Consolidated Permit PP3834CB

CAR report dated 16/10/13

Ruabon Spray Drier
- mixture of dielectric (non Pb) & PZT (Pb)

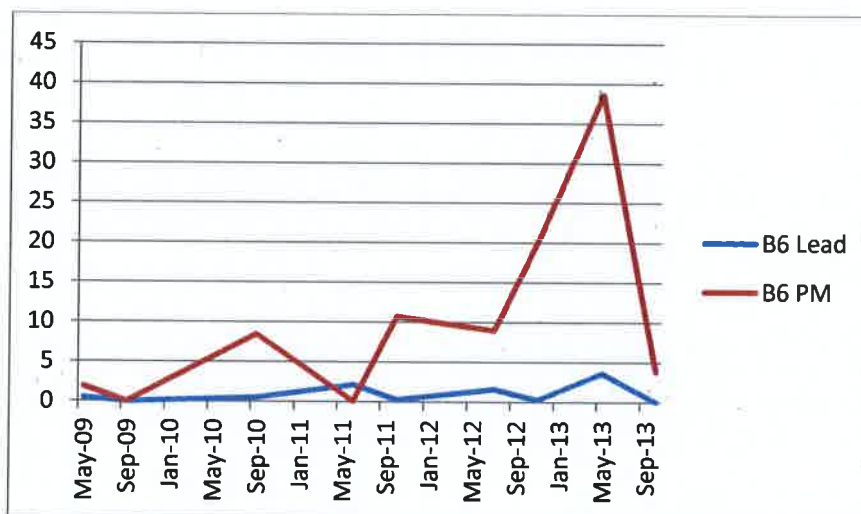
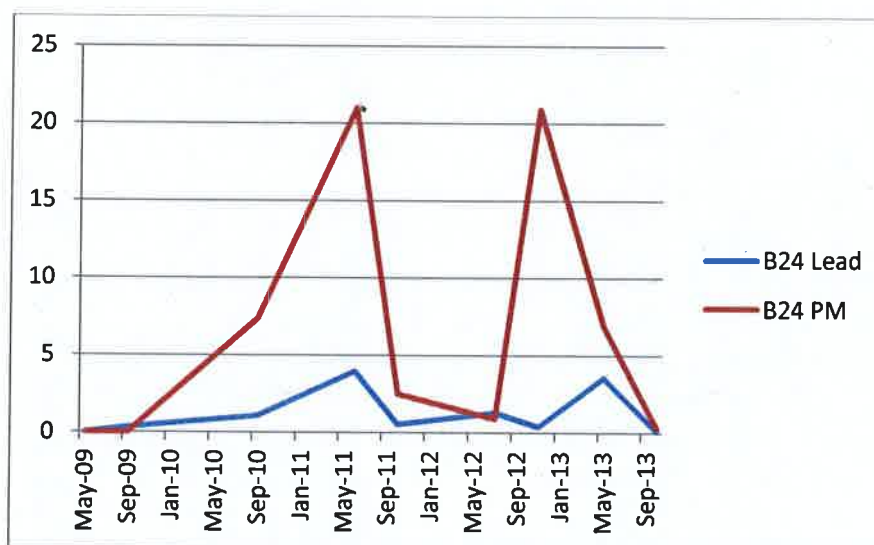
IC 2 – Operator to submit a report on how the scrubber performance will be monitored. E.g. Is there a correlation between Pb and PM from the dryers, is it possible to use PM monitoring as a surrogate Pb measurement?

scale mg/m³?

why not reported a breach.

The Ruabon and Eindhoven spray driers emit to the scrubbers B6 and B24 respectively. The results taken every 4 months for the past 4 years have given results as shown in the graphs. As can be seen from the graphs there is no correlation between the amount of particulate matter emitted and the lead content of the emissions.

This is due to the fact that the powder batches through the spray driers are either lead based (PZT) or non-lead based (Dielectric). B6 can be a mixture of di-electric and PZT whereas B24 is PZT only.

The scrubbers will continue to be monitored three times a year by Environmental Evaluation. The levels of 0.2 mg/m³ and 3mg/m³ for B6 and 0.2 mg/m³ and 2 mg/m³ for B24 from the permit appear very low compared to the results that have been achieved.

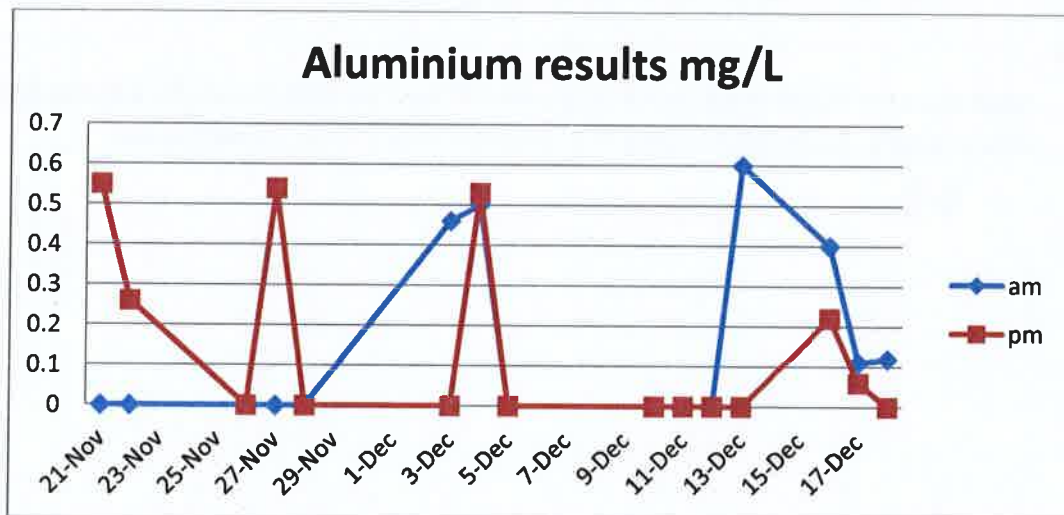
IC 6 and S1.4 - Operator to collate the Al results from DCWW using the new sample location. Operator to analyse for Al (and Pb, not required by this IC but required for permit breach work) for worst case batch/product. The period of analysis must be of sufficient length that the results are statistically meaningful. Monitoring equipment, techniques, personnel and organisations employed for the emissions monitoring programme shall either have MCERTS certification or MCERTS accreditation as appropriate (ref. Section 3.3.3 of permit).

old monitoring point

As expected the level of aluminium increased during 2013 as the aluminium electrode was utilised.

The results from Hydro are on the graph below

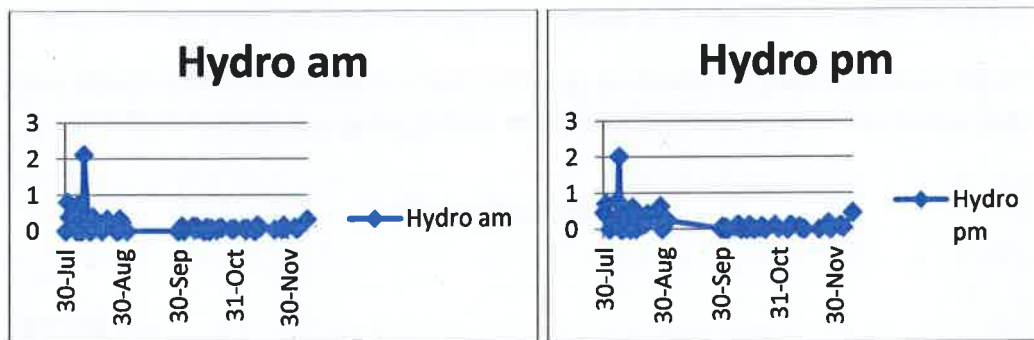
happy with results

The results seen are less than 1mg/L. It is proposed to continue monitoring these results until full commissioning of the ETP has been completed.

The lead results are as follows:-

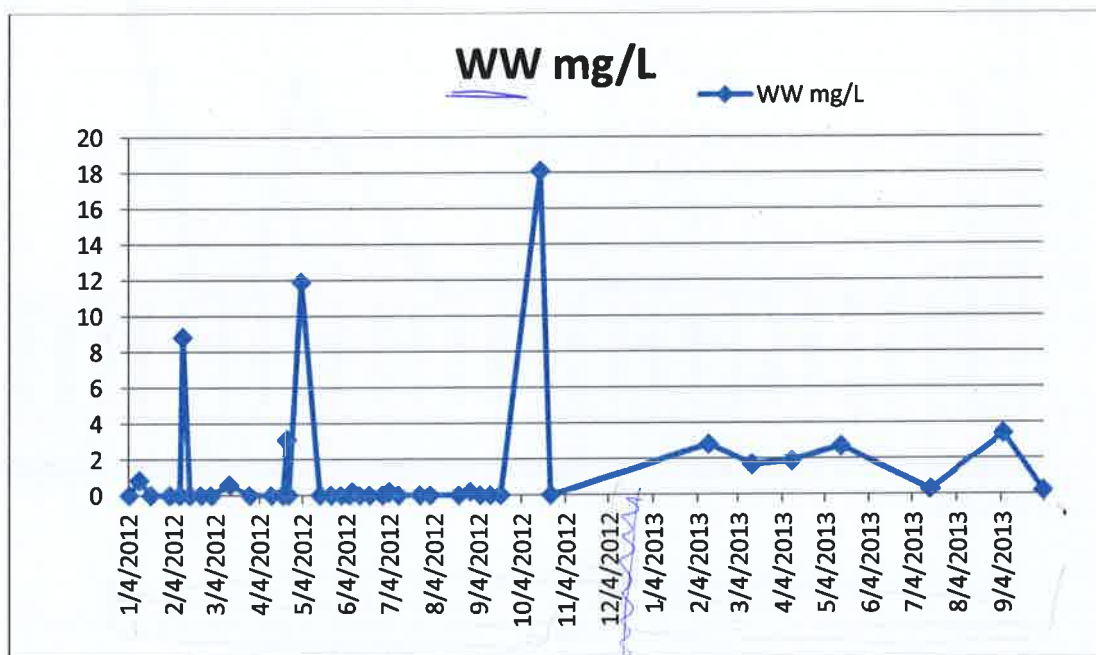
0.5

As can be seen from the Hydro lead tests they have only detected lead above 2 on one occasion both a morning (09/08) and an afternoon (07/08).

Looking at the Welsh Water results after the ETP was installed the results are generally below 2mg/L. As discussed above the ETP will continue to be commissioned.
